## ADDENDUM No. 1

**PROJECT:** Spartanburg Community College  
**Tyger River HVAC and Boiler Replacements**  
OSE Project No. H59-6315-JM  
DEVITA Project No. 25531

**DATE:** February 18, 2026

**DRAWING NO.**  
**M102**  
Drawn By: ASE Checked By: CIC

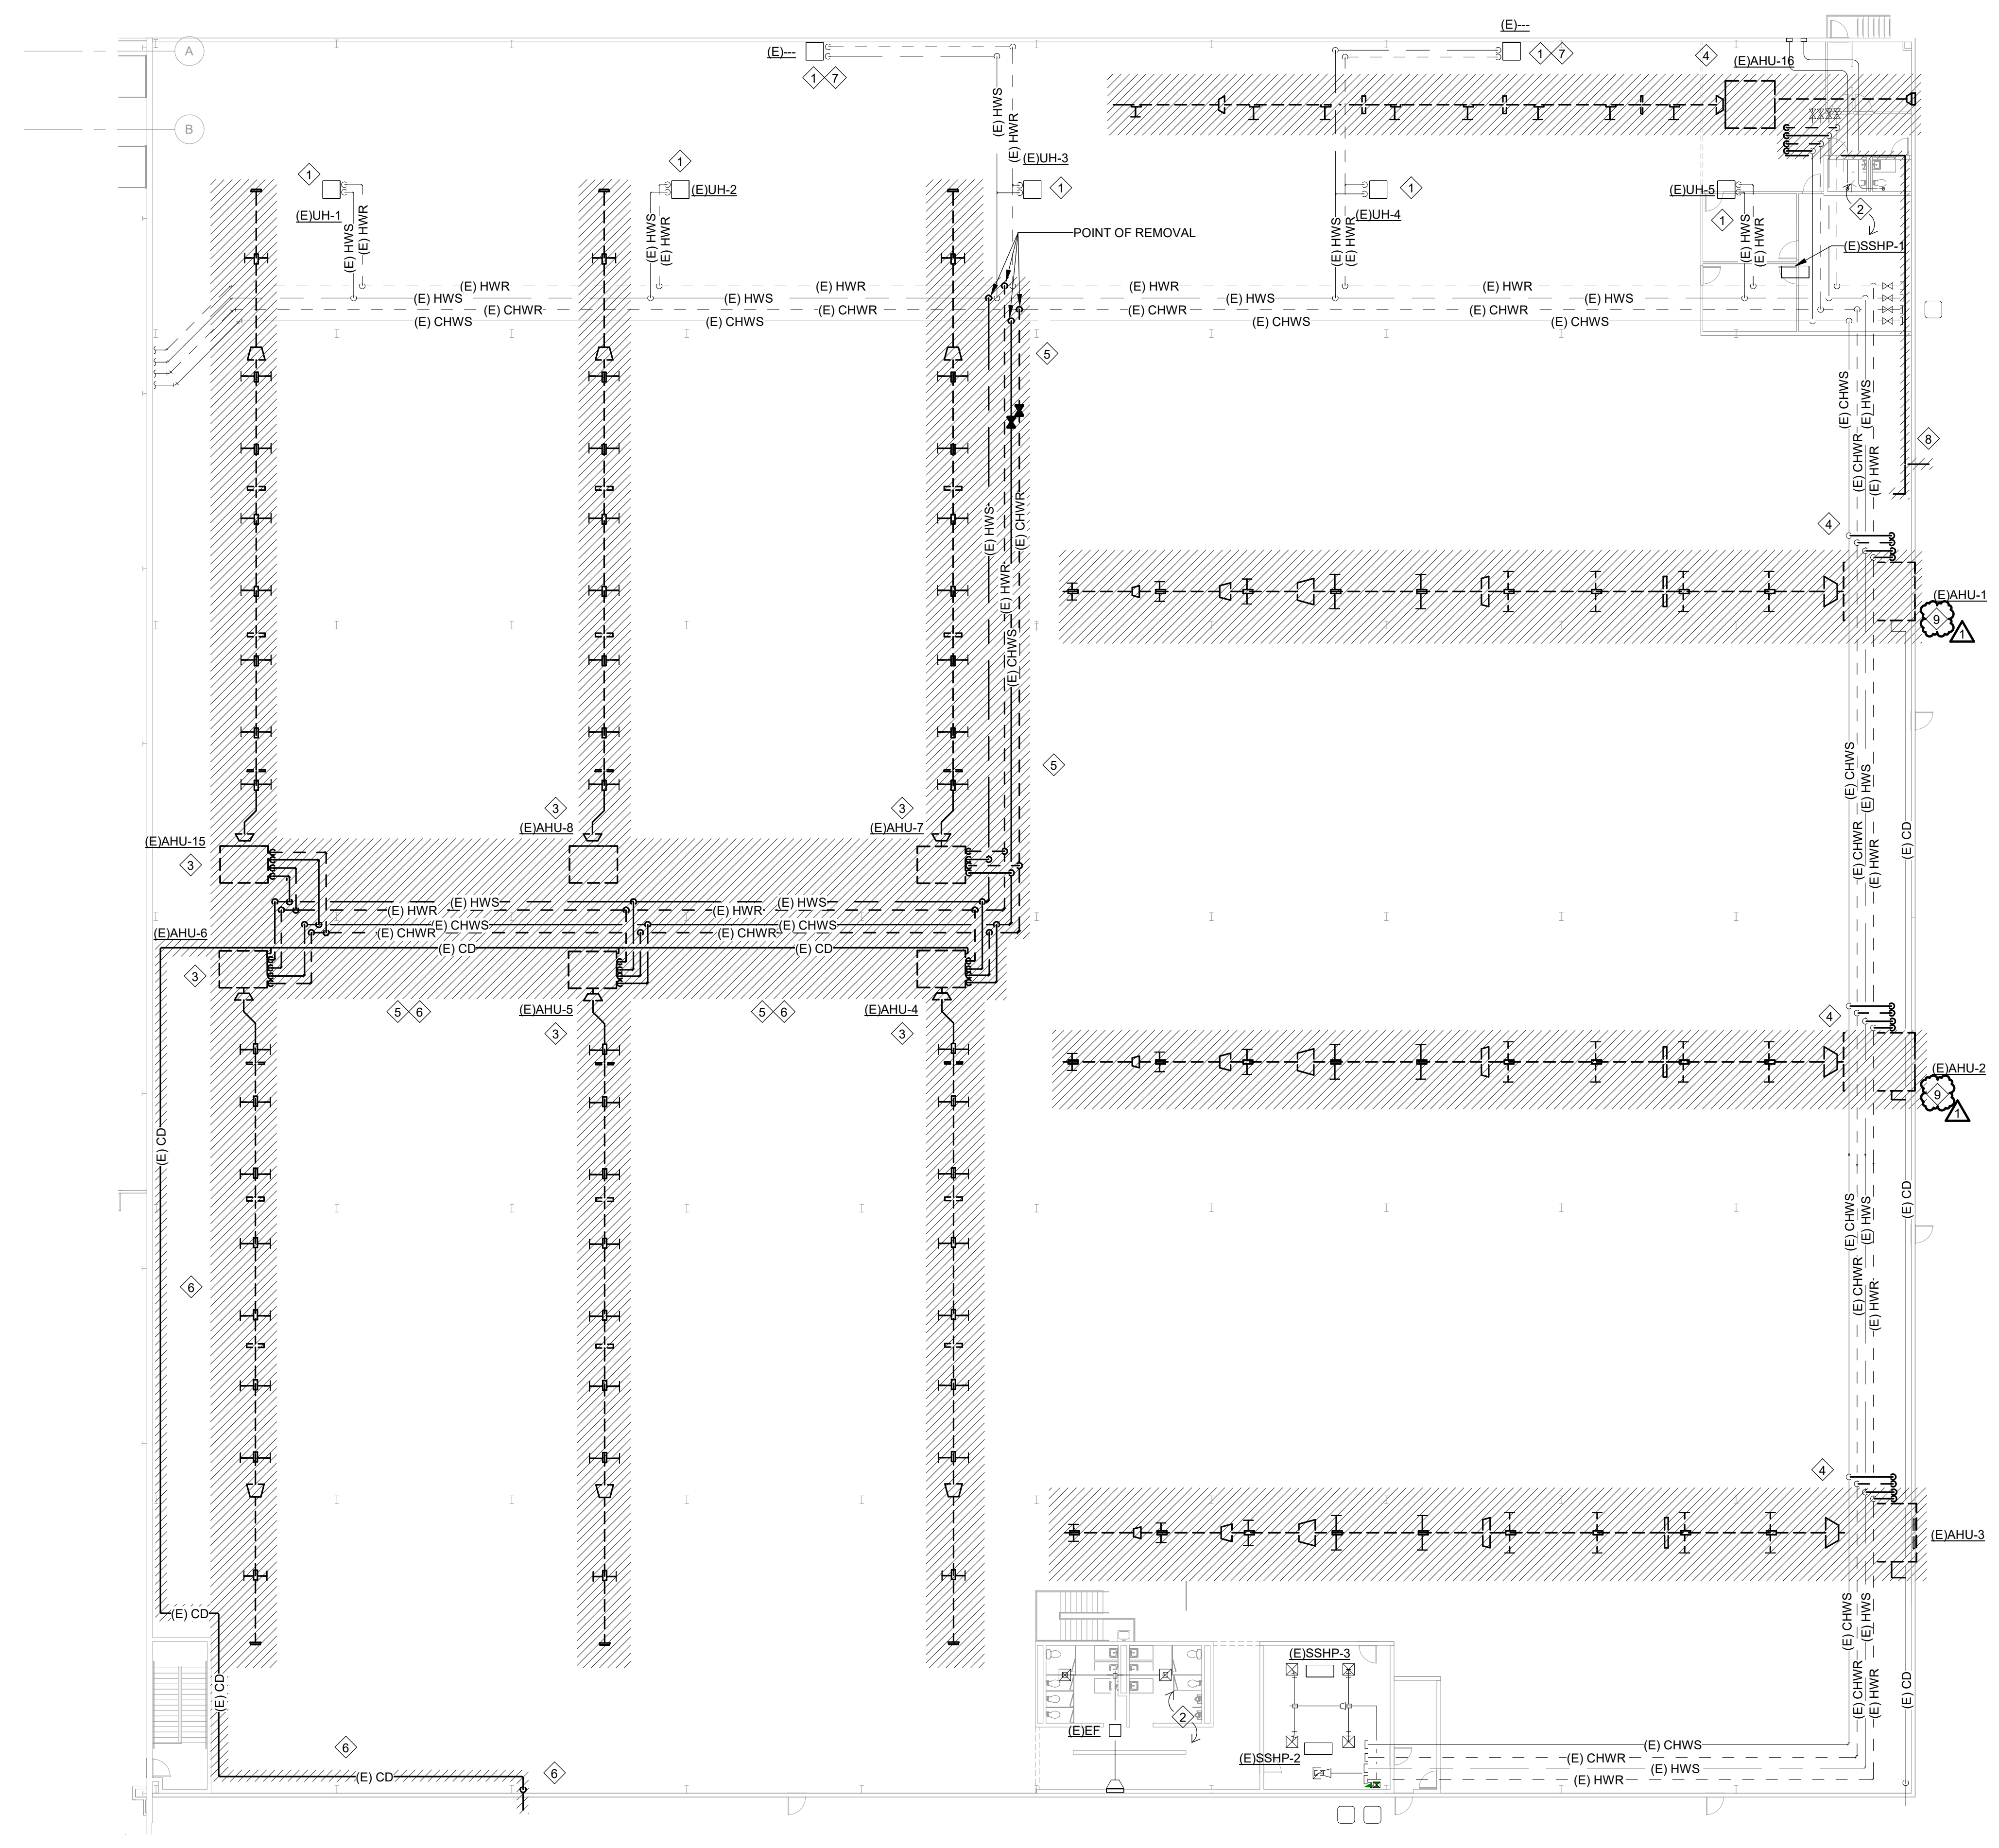
- Added note 5 to cover capping existing outside air louvers.

DRAWING NO.  
**M105**  
Drawn By: ASE Checked By: CIC

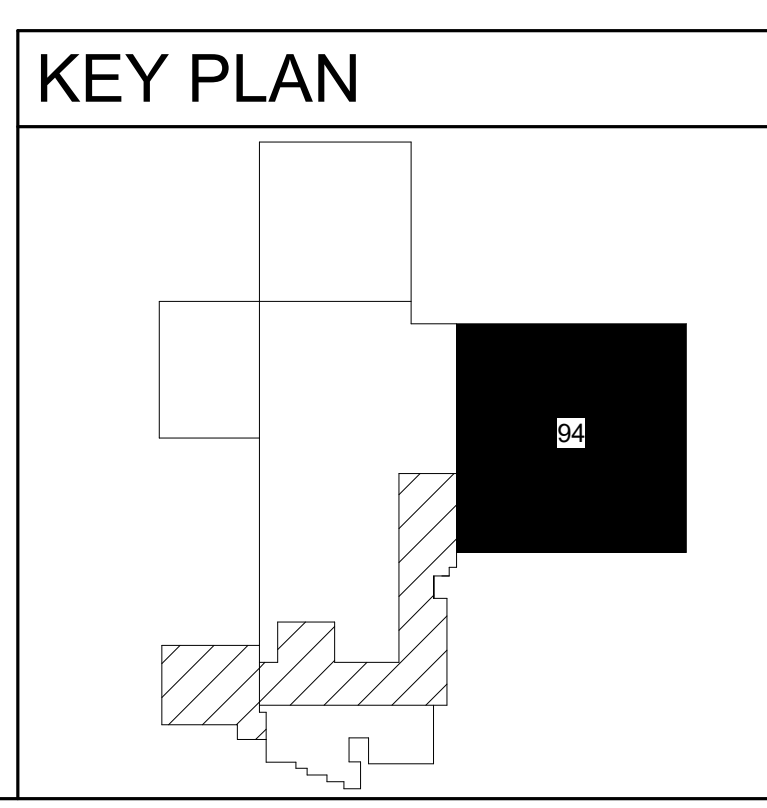
- Added note 9 to cover preparation of existing outside air louvers.

9. REMOVE OUTSIDE AIR DUCTWORK ASSOCIATED WITH EXISTING AIR HANDLER BACK TO LOUVER. EXTEND NEW OUTSIDE AIR DUCTWORK FROM LOUVER AS SHOWN IN NEW WORK PLAN.
